MP7 345R Throttle Delay at Cold Start LEU, MRU

FSB 284-062, MP7 345R Throttle Delay at Cold Start

(July 2015)

W2102733

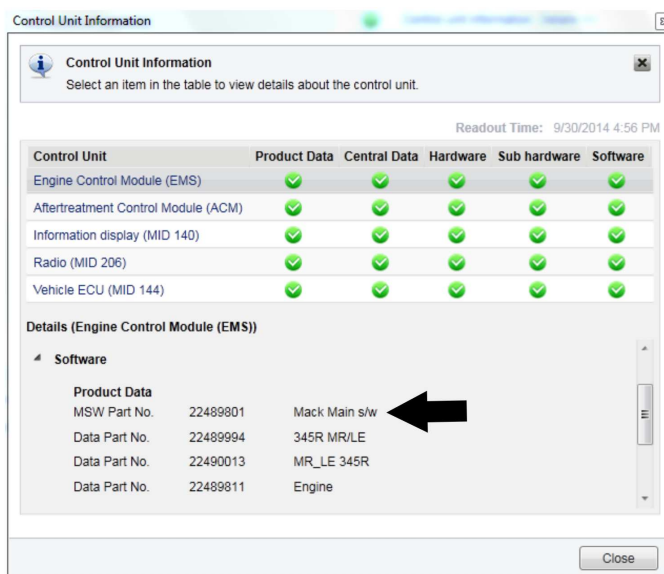
Certain MACK MP7 345R engines built between February 7, 2014 and July 6, 2015 may experience excessive throttle delay at start up during extremely cold ambient temperatures until normal engine operating temperatures are achieved. Improved software has been released to address this condition.

If a chassis is experiencing the throttle delay as described in this bulletin, check the software level in the engine control module (ECM). Check for engine main software part number as shown below and compare to the table information.

Main Software Part Number	US2014 (Model Year 2015)	22572319 or less	Proceed with software update
		22665162 or higher	Open an eService and report the issue
	OBD2015 (Model Year 2016)	22644017 or less	Proceed with software update
		22687466 or higher	Open an eService and report the issue

Refer to service information in Function Group 284 to reprogram the engine control module (ECM).
